National Commission on Air Quality

July 10, 1980

I have reviewed the comments on "A Method for Calculating Doses to the Population from ^{133}Xe Releases During the Three Mile Island Accident" that were provided with your 9 June 1980 letter.

Figure 3-5E. x_u/Q with distance for various heights of emission (H) and limits to vertical dispersion (L), E stability.

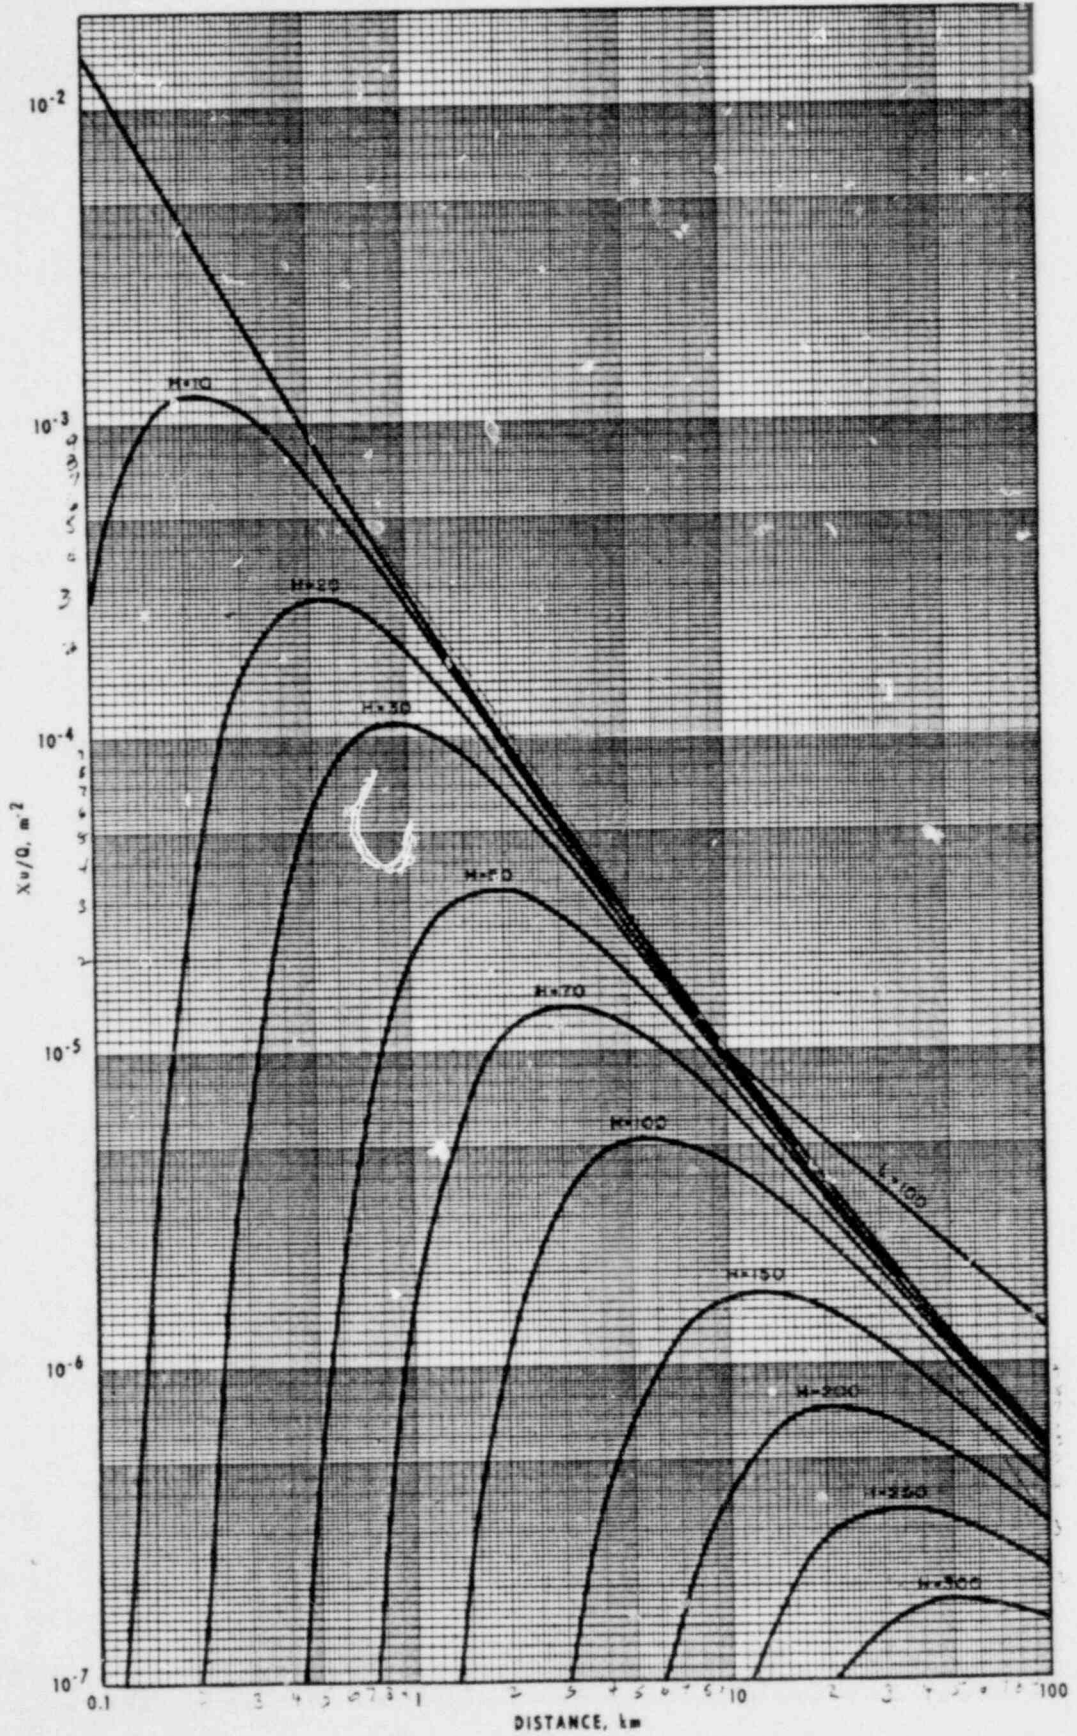
The reviewer comment on use of the assumption of concentration decreasing as distance to the 1.5 power is interesting, particularly in the assertion that the assumption is "not valid for sustained ground level releases (or at distances where such may be assumed.)" If this assumption is valid anytime, it is for ground level releases. A few quick calculations from Turner's "Workbook of Atmospheric Dispersion Estimates" may illustrate the point. Most of the releases at Three Mile Island were made during slightly stable ("E" stability) conditions. I've enclosed a copy of Figure 3.5E from Turner's Workbook to illustrate the decrease of downwind centerline concentrations (as computed from the simple Gaussian straight-line model) for various release heights during E stability conditions. Note that only for a ground level release does concentration monotonically decrease with distance with a slope that approaches $-3/2$, particularly for distances greater than 1 km. Of course, building wake effects would distort the shape of the concentration curve close to the source and reduced mixing heights and reflection off the surface and inversions distort the shape of the curve at very long distances, approaching 100 km. However, the uncertainties of X/Q at such long distances are probably more a function of the validity of assumed straight-line airflow and the representativeness of single-station meteorological data. Using the sector-spread model for E stability and an assumed ground level release also results in the slope of concentration versus downwind distance approximately $-3/2$. Using the sigma-Z curves of Turner (which probably vary slightly from those used by the NRC) for E stability relative concentrations can be easily calculated for a ground level release by the formula:

The slope of concentration with downwind distance is approximately $-3/2$, particularly for distances greater than 1 km.
